Carencro City Hall Expansion

Carencro, Louisiana

June 8, 2026

Drawing Title ELECTRICAL POWER & SPECIAL SYSTEMS		
Designed PM, CM	Project No. 2024.006	
Drawn GW	Scale AS NOTED	
Checked DS	Drawing No. E.101R2	
Reviewed	Date FEB. 10, 2026	
Date FEB. 10, 2026 81 of 83

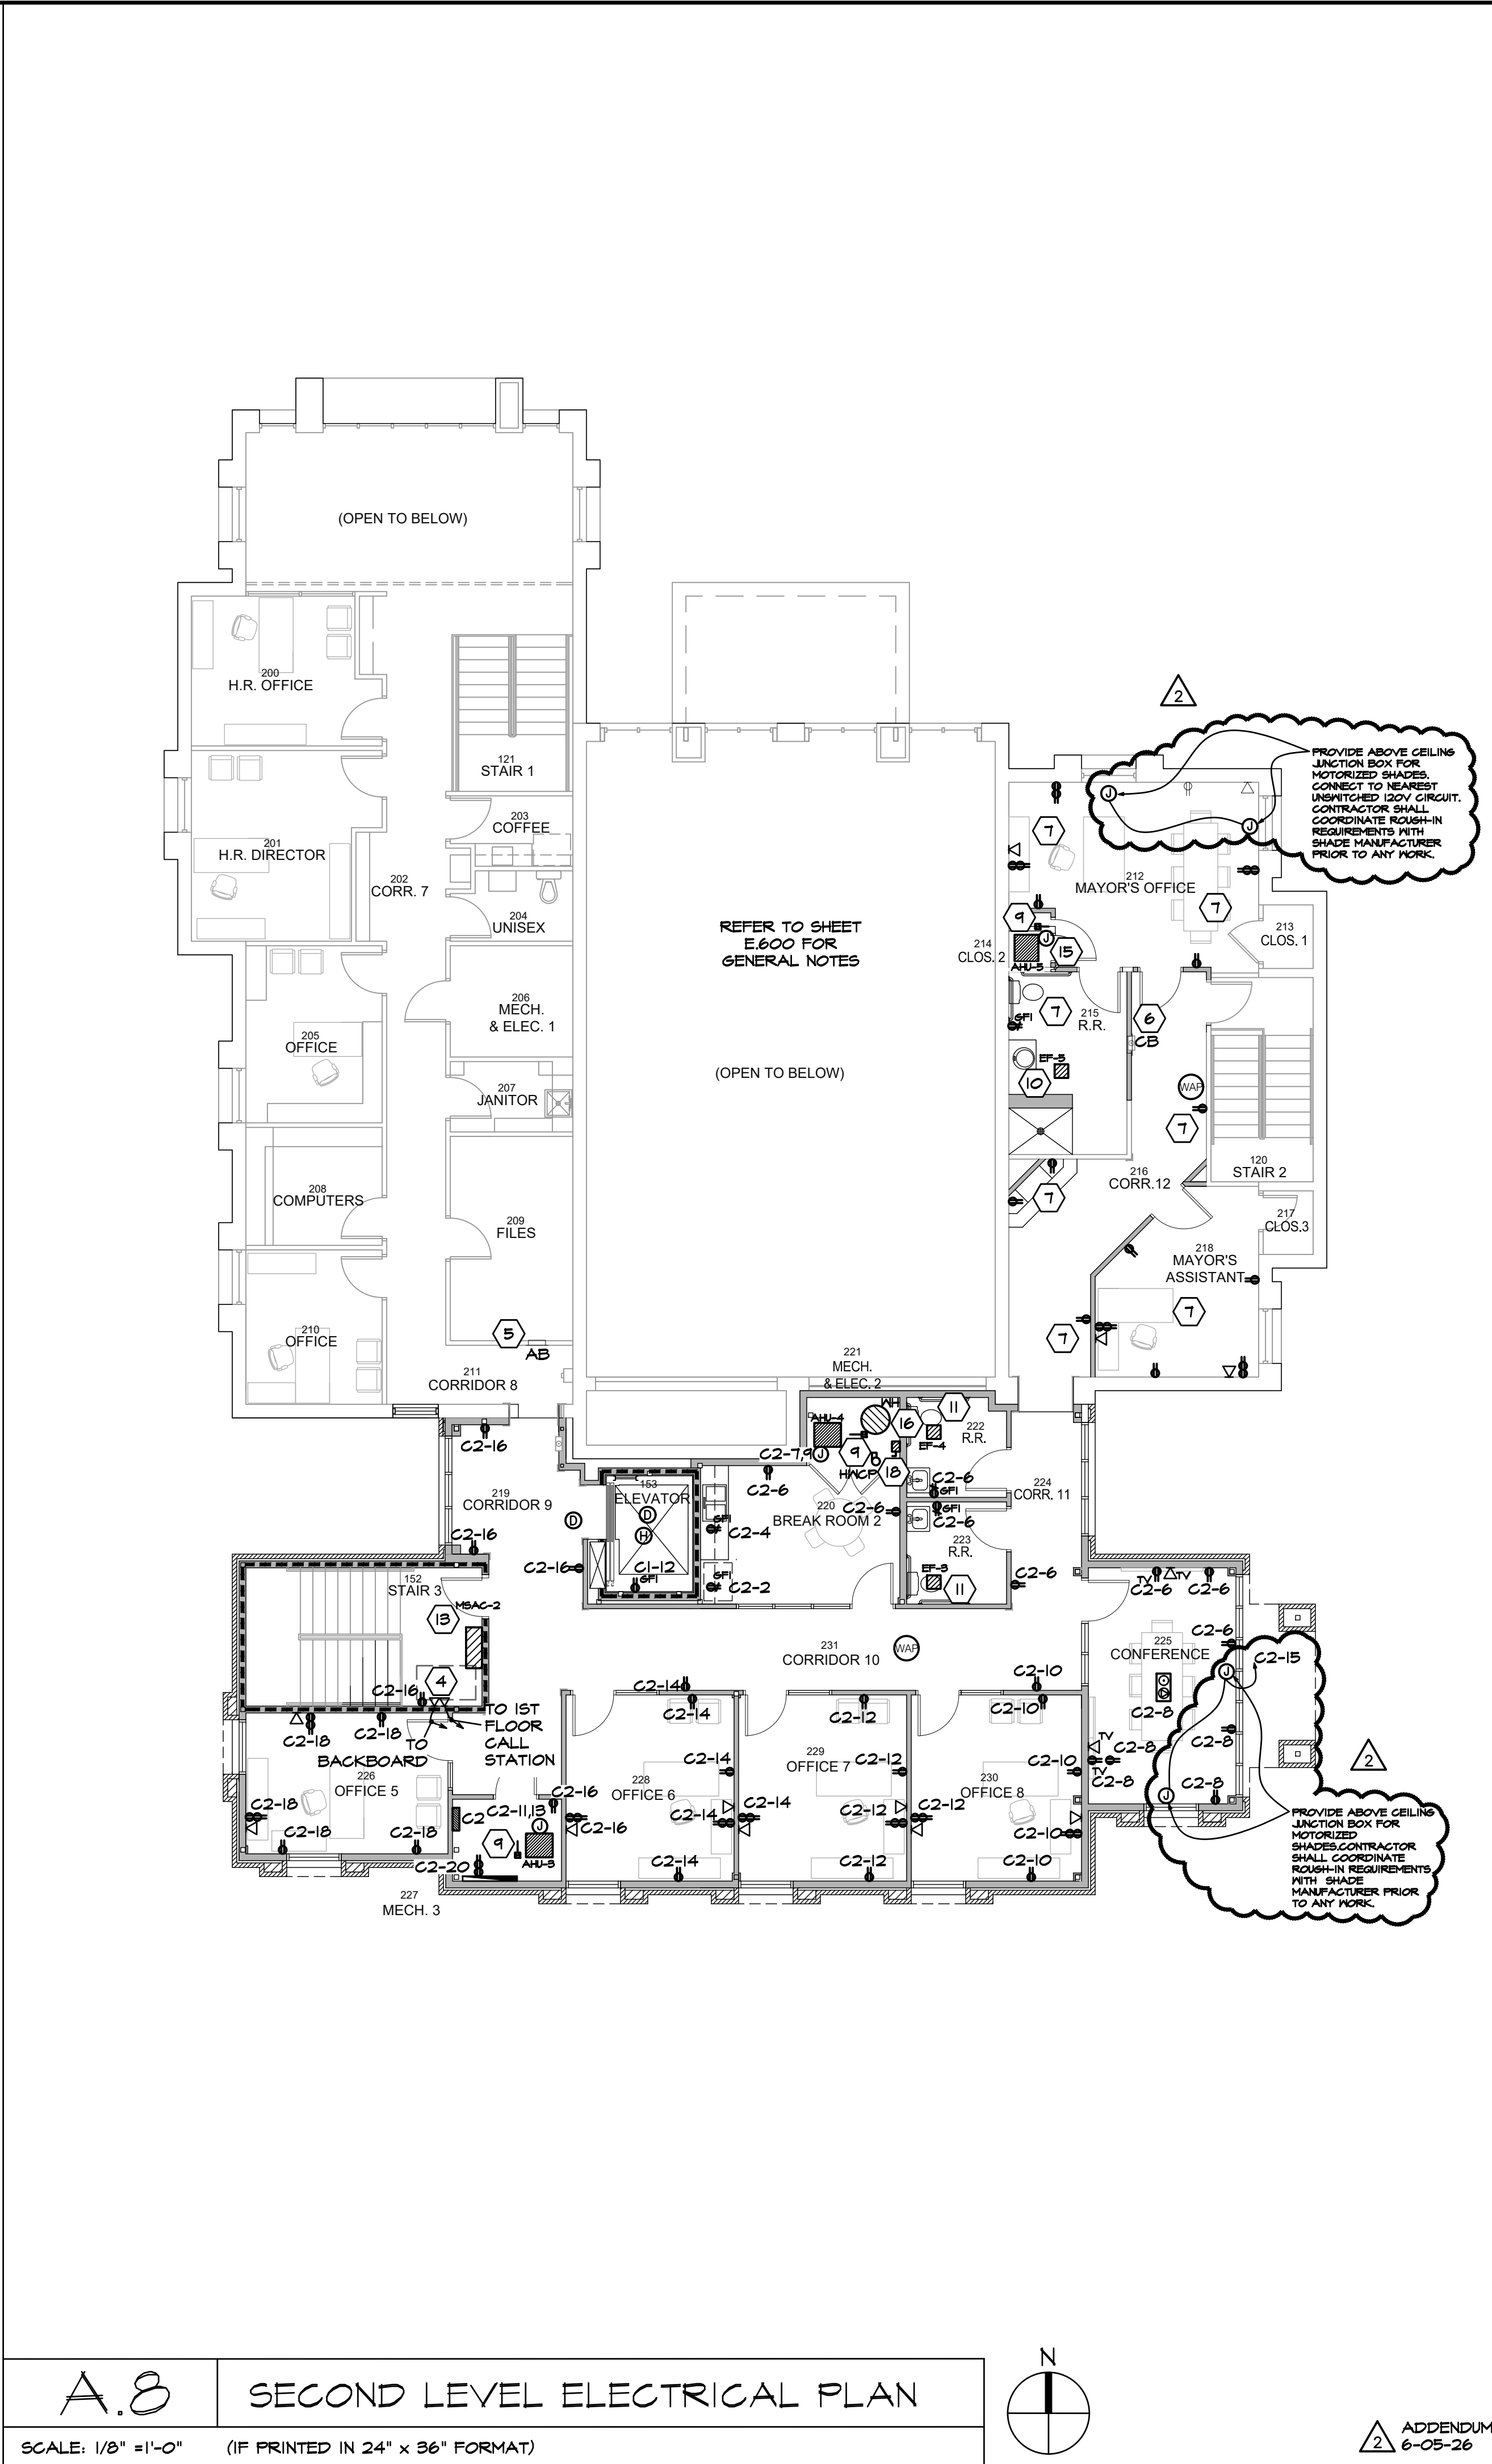
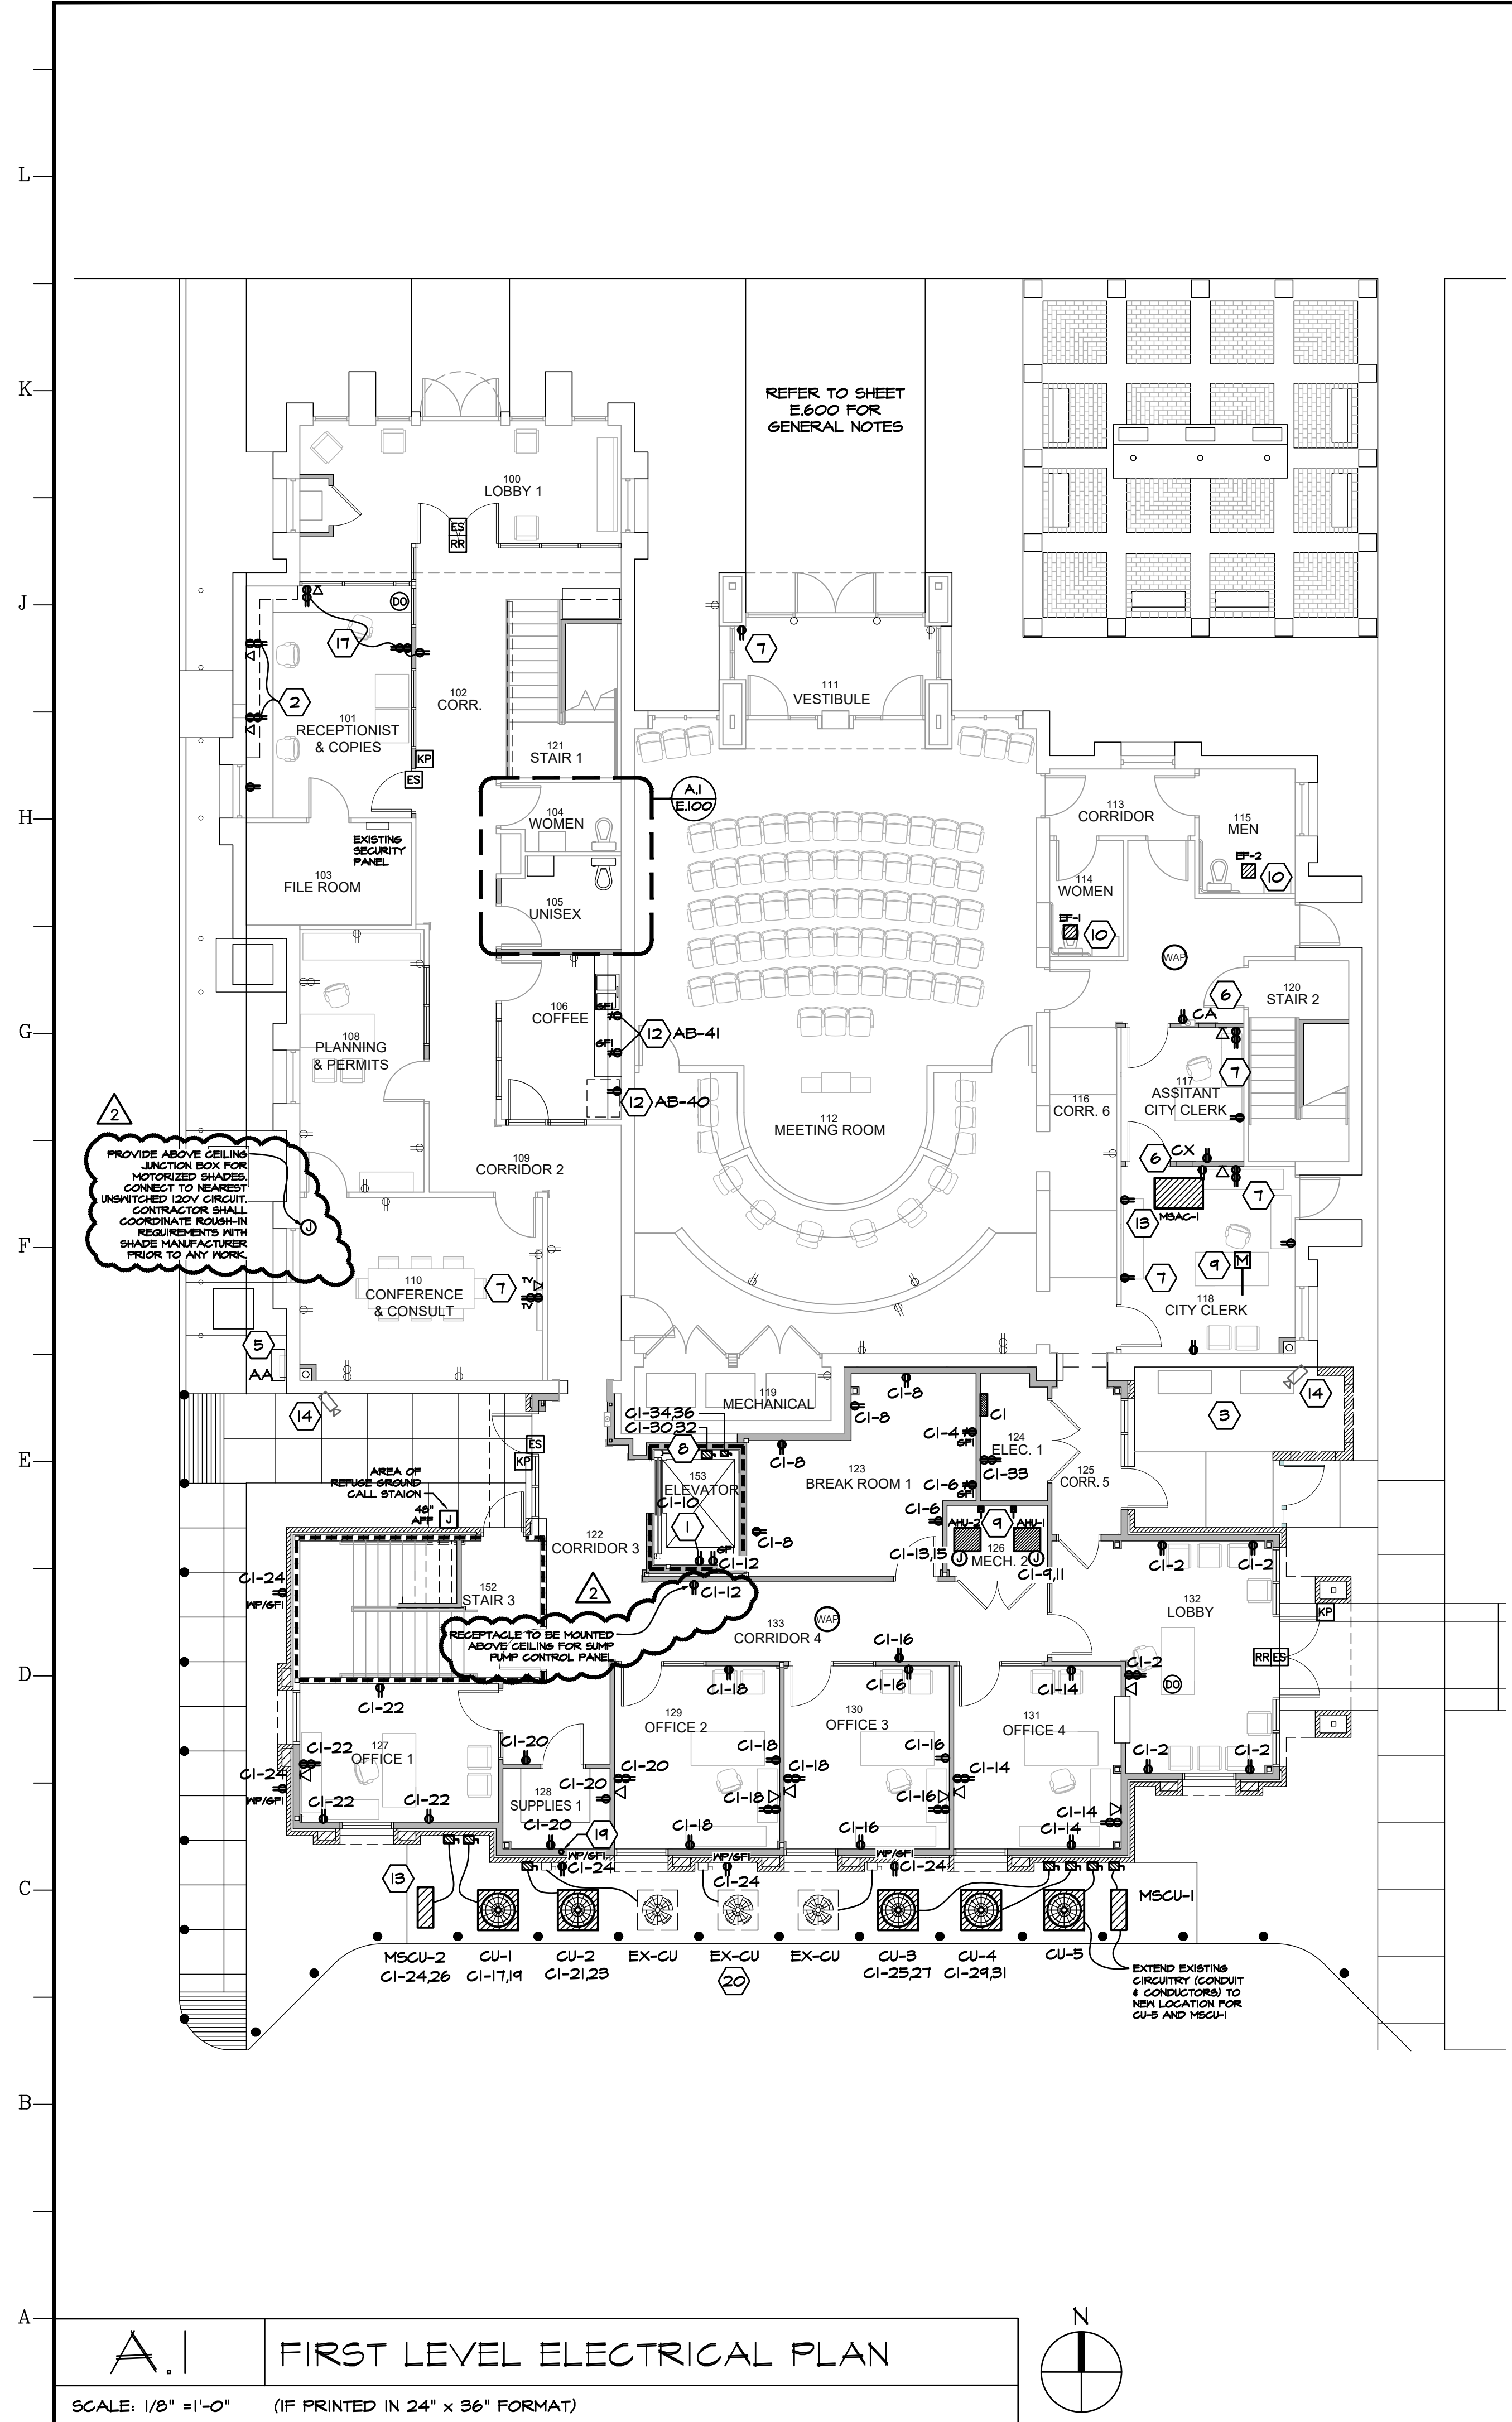
- i. Replace previously issued sheet E.101R1 in its entirety with the attached revised drawing E.101R2. See Attachment No Six (6).

- ELECTRICAL KEYNOTES:**
- 1 SUMP PUMP RECEPTACLE. CONNECT TO PANEL CIRCUIT INDICATED.
 - 2 CONNECT OUTLETS TO NEW 120 VOLT, 20 AMP CIRCUIT. PROVIDE A NEW CIRCUIT BREAKER AND A NEW TYPE WRITTEN PANEL SCHEDULE.
